Replace the following components on the servo PCB

Replace D507 on main PCB for CDi/CDt/CD Xt Signature if within the following serial number range:

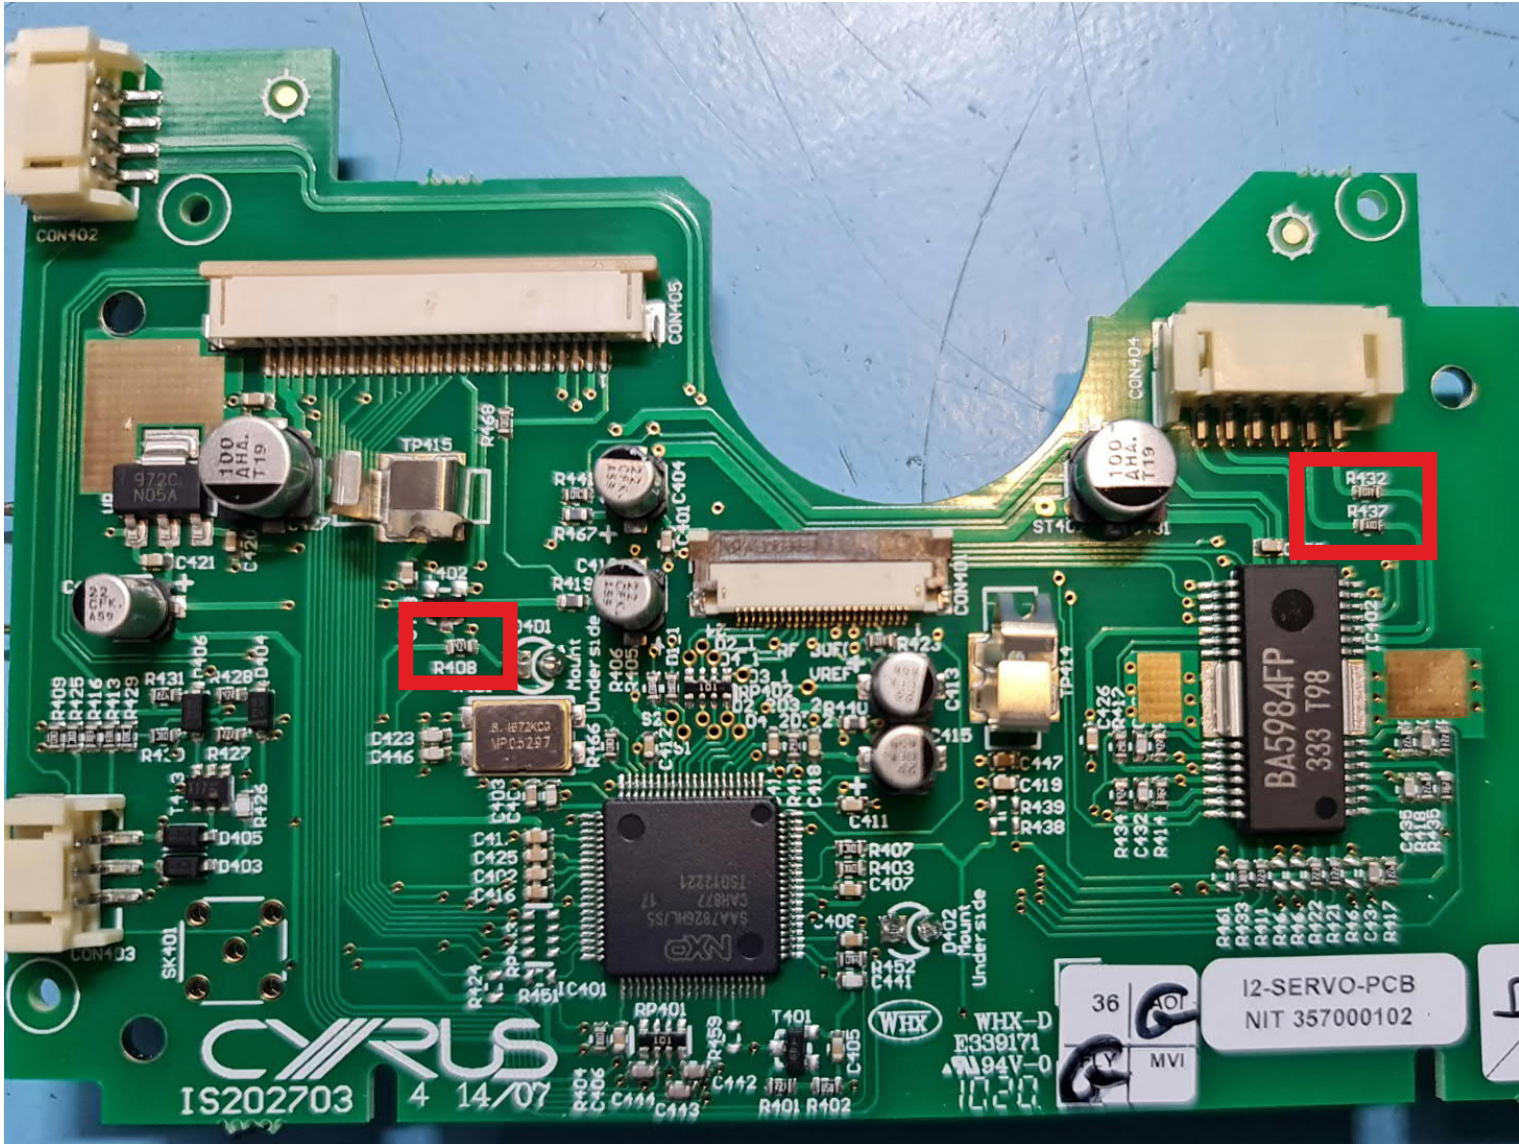
R432 and R437 from 1R to 0R resistors (Welwyn 1% 1/16W 0603)

Change R408 47R (SMD0603 1%) to 470R (SMD0603 1%)

CDi Brushed - BN2EB4460 to BN2EB7200  
CDi Quartz - BN2EQ3325 to BN2EQ5010

CDt Brushed - BM2EB4027 to BM2EB6050  
CDt Quartz - BM2EQ3503 to BM2EQ5010

CD Xt Signature Brushed - BJ2EB4000 to BJ2EB4240  
CD Xt Signature Quartz - BJ2EQ3500 to BJ2EQ4010

D507 should be changed to the following:  
Manufacturer: TEXAS INSTRUMENTS  
Manufacturer Part No: TL432BQDBZR  
Farnell Order Code: 3124635
